INNOLUX 群創光電

Customer ECN

File No: CPI-EC240047

Model Name:	R190EFE-L51	**Available Date:**	2024Q3
Change Reasons:	Due to Tcon IC ,BEF and Polarizer material EOL.		
Change Contents:	Tcon model change from MST7502B to NT71735MQG BLU-BEF change from HPS510 to P250ML-I Polarizer change from NAZ195 to NAZ270

Module Version List：

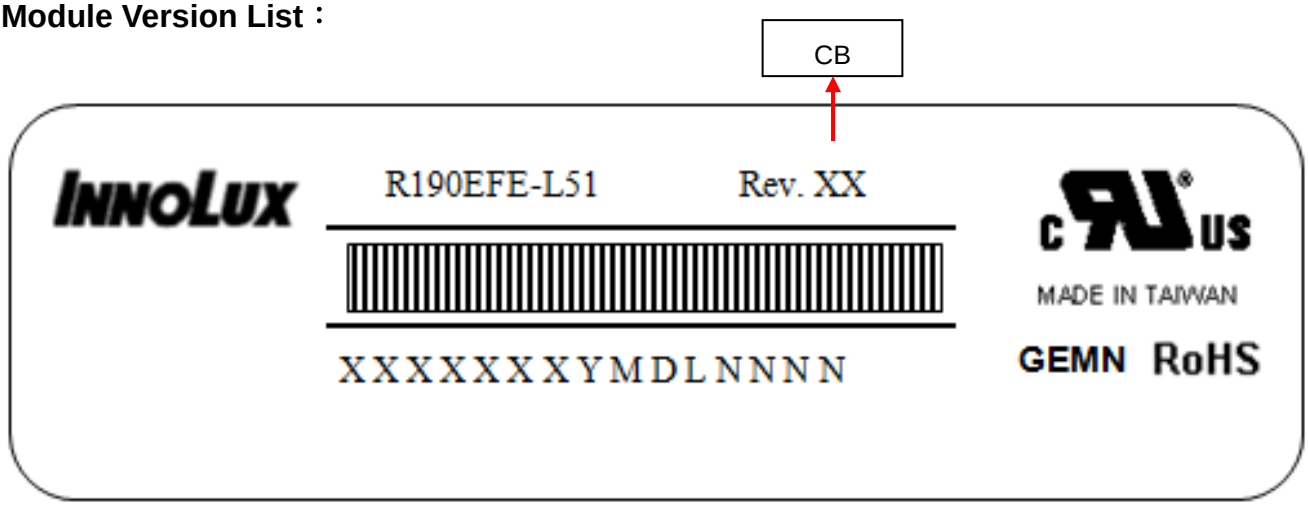
Changed Items	Before Change	After Change
Version	C9	CB
Tcon IC model	MST7502B	NT71735MQG
BEF model	HPS510	P250ML-I
Polarizer Compensation Film	NAZ195	NAZ270
